Office Action Summary

10/810,273

DETAILED ACTION

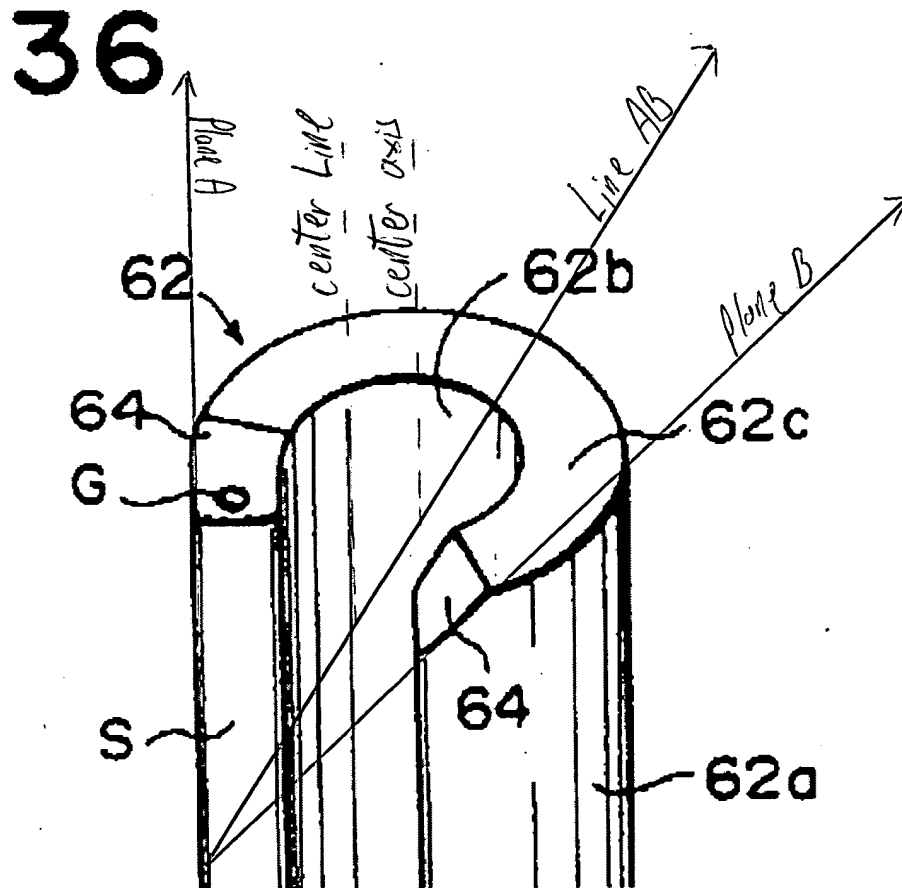
Chamfered portions (figure 36, item 64) are provided at edge portions of the opening of said clamp member (figure 36, (column 20, lines 37-42)), said chamfered portions having a slope orthogonal to a plane passing between a center axis of the

cylindrical body and a center line of the opening (see figure 36 below, any plane that is orthogonal to line AB will be orthogonal to the slopes of both chamfered portions and will pass between the center axis and a center line of the slit).

A tape cartridge according to claim 1, wherein each of said chamfered portions is formed over to an end surface of said cylindrical body that faces said collar portion (column 20, lines 37-40), to a side surface extending in the longitudinal direction of said opening and to an outer peripheral surface of said cylindrical body (figure 36, inclined guide surfaces [64] are slanted and extend the width of the clamp).

A tape cartridge according to claim 1 or 2, wherein said chamfered portions are provided at both of shoulders facing each other with said opening interposed therebetween (figure 36, inclined guide surfaces are on the shoulders of clamp end portions of slits and they face each other across the slit).

A tape cartridge according to claim 1, or 2, wherein a chamfering angle made by a chamfering line of said chamfered portion and by the side surface extending in the longitudinal direction, falls within a range of 20 through 50 degrees (figure 36, inclined guide surfaces are at an angle of about 30° to 45°).
